Avery Brook Homes

Water Quality Concerns of Groton Utilities

March 7, 2023

Michael Giggey, PE

Groundwater contours reported by Fairbank

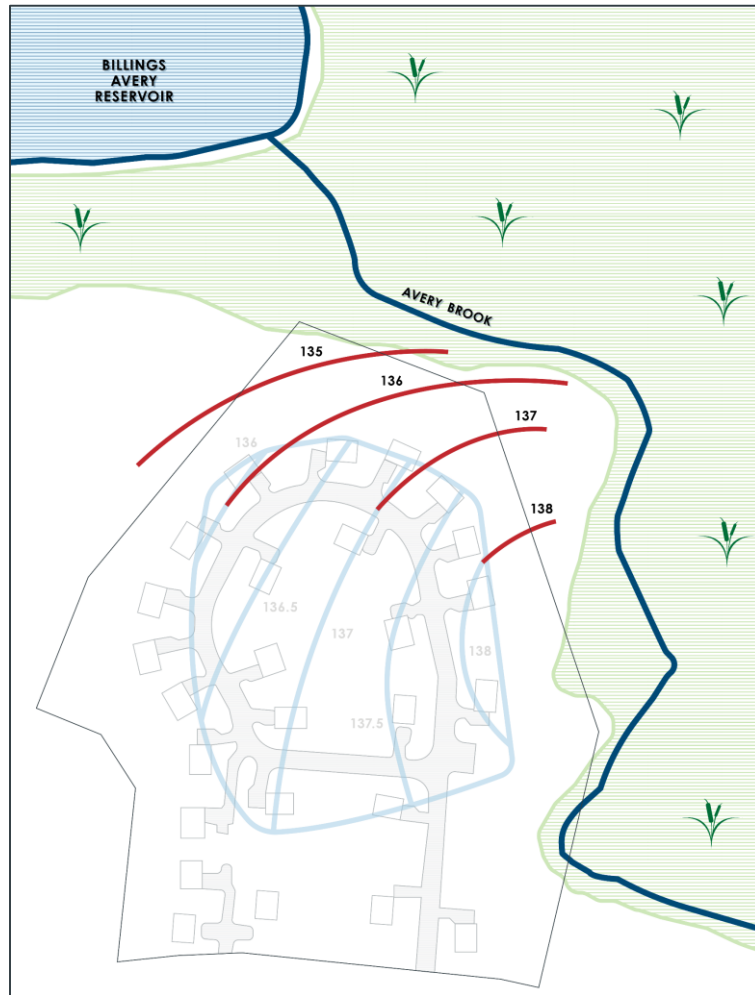
- Data limited to central portion of site
- Apparent NW'ly flow of groundwater

Groundwater contours—reasonable extrapolation

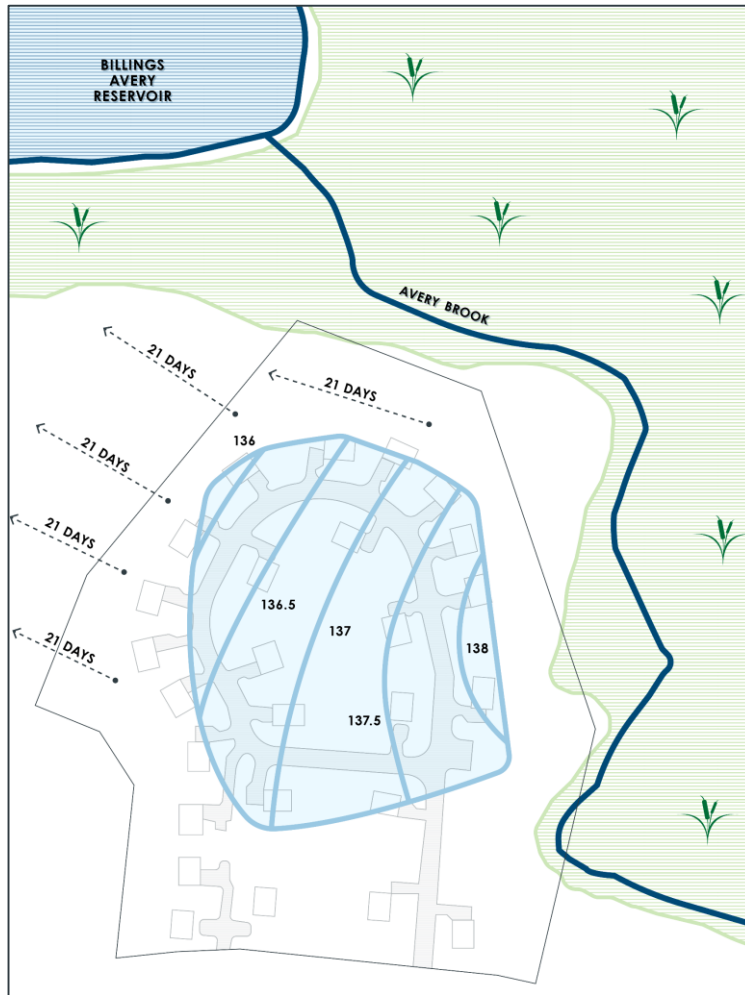
- Contours bend to the north as groundwater interfaces with Avery Brook
- Groundwater flow in SE corner not addressed

Virus inactivation—distances reported by Fairbank

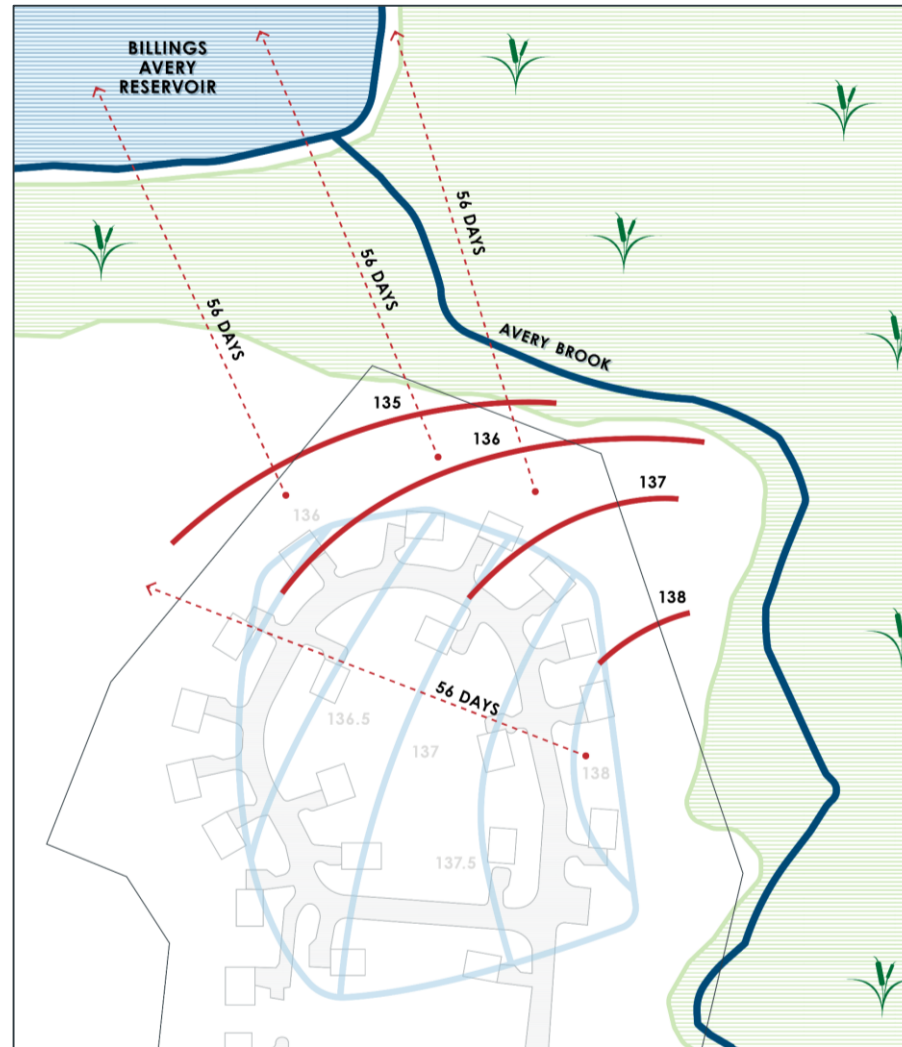
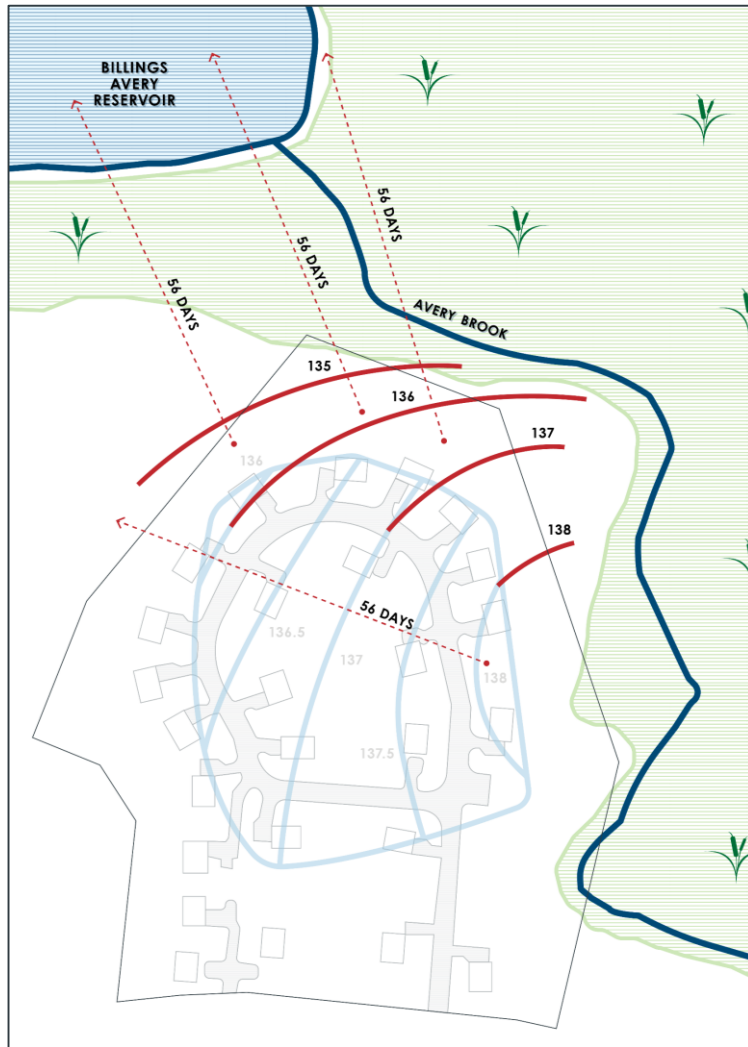
- Based on NW'y flow
- Based on 21-day inactivation period
- Demonstrated impact on abutters

- Consider likely flow to the north
- Consider 56-day inactivation period
- Expect impacts on
 - Avery Brook
 - Billings Avery Reservoir
 - Many on-site potable wells
 - Abutters' wells

Groundwater nitrate map

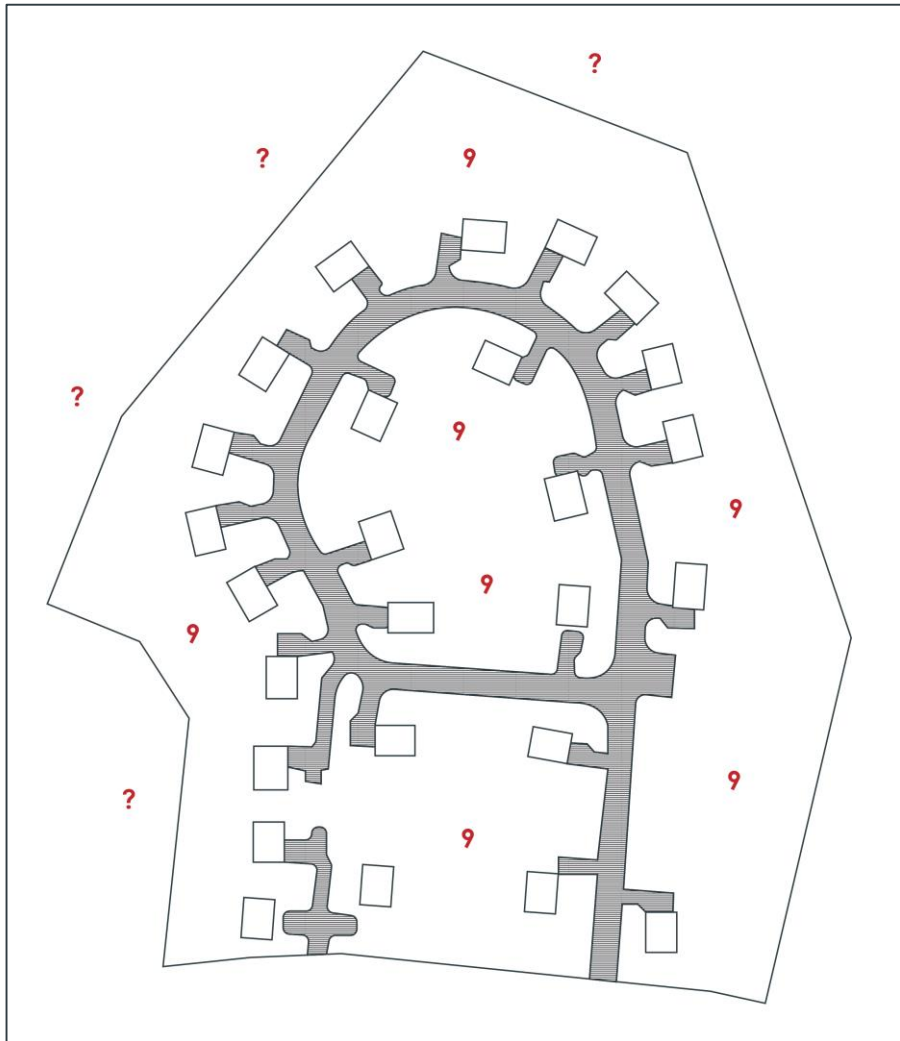
- Based on Fairbank calculations
- Site average recharge concentration---9 mg/l
- Concentrations at property lines not estimated

Groundwater nitrate map

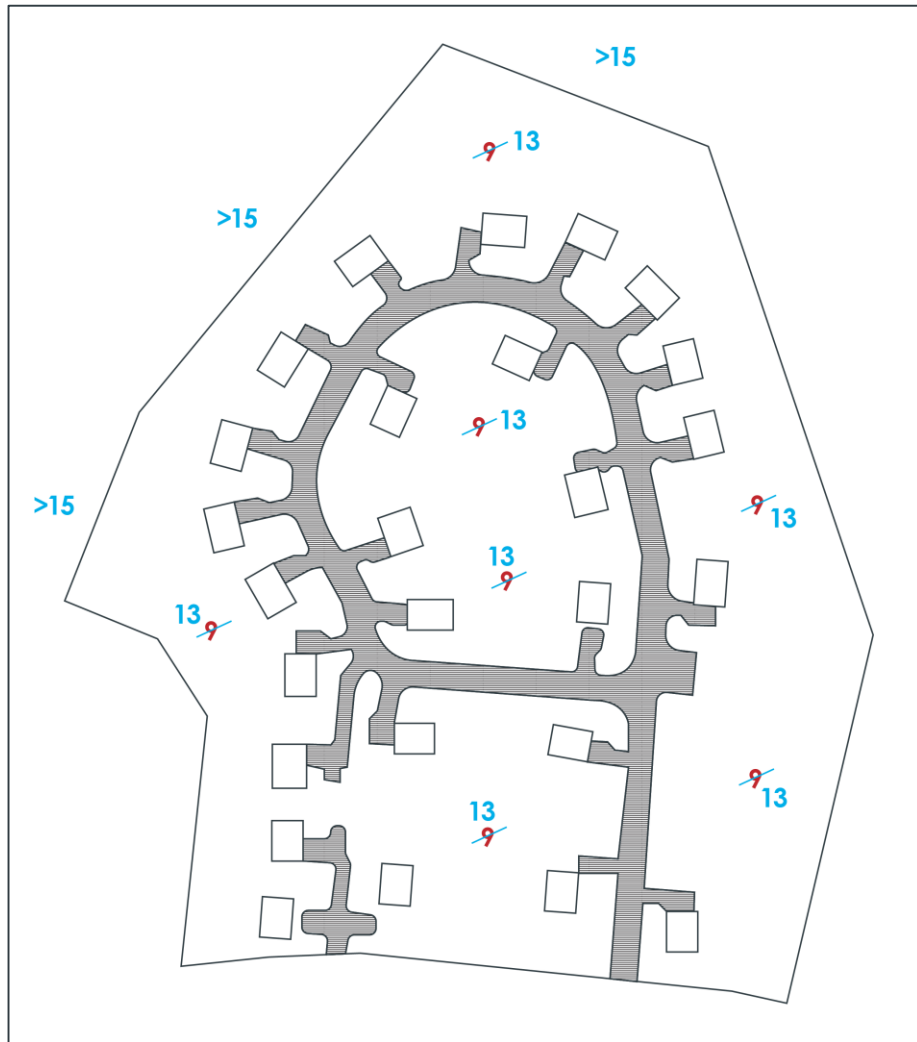
- Based on Wright-Pierce calculations
- Site average recharge concentration—13 mg/l
- Property line calculations well above 10 mg/l
